Delegated Report

Planning Application No: 20250578

Location: 19 Henley Deane, Northfleet, Gravesend DA11 8SU

Description: Erection of a brick wall with piers in front garden.

PRE EXISTING GROUND FLOOR PLAN

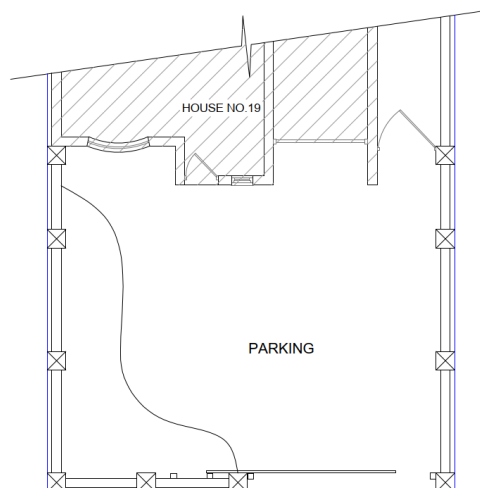
The existing walls and proposed railings do not respond to the design of the dwelling and are not consistent with the height of other enclosures on the road. There is no well-maintained planting and the hedgerow has not been retained. As discussed in the Highways section below there are insufficient visibility splays and sight lines for pedestrian and vehicular safety.

The brick piers are approx. 1.6m in height. At these heights, they restrict the visibility of drivers exiting the property. Moreover, the gate (once installed) would not be set back far enough from the back edge of the road to enable a car to wait clear of the highway while it is opened. This situation is such that a car waiting to enter the property would obstruct Henley Deane to the detriment of highway safety. This is considered to be particularly the case as the access to 19 Henley Deane is close to the junction between this road and the nearby cul- de- sac at Wrens Croft. The development is therefore contrary to the requirements of saved Policy T1 of the Gravesham Local Plan First Review (1994) and Policy CS11 of the Gravesham Local Plan Core Strategy (2014).
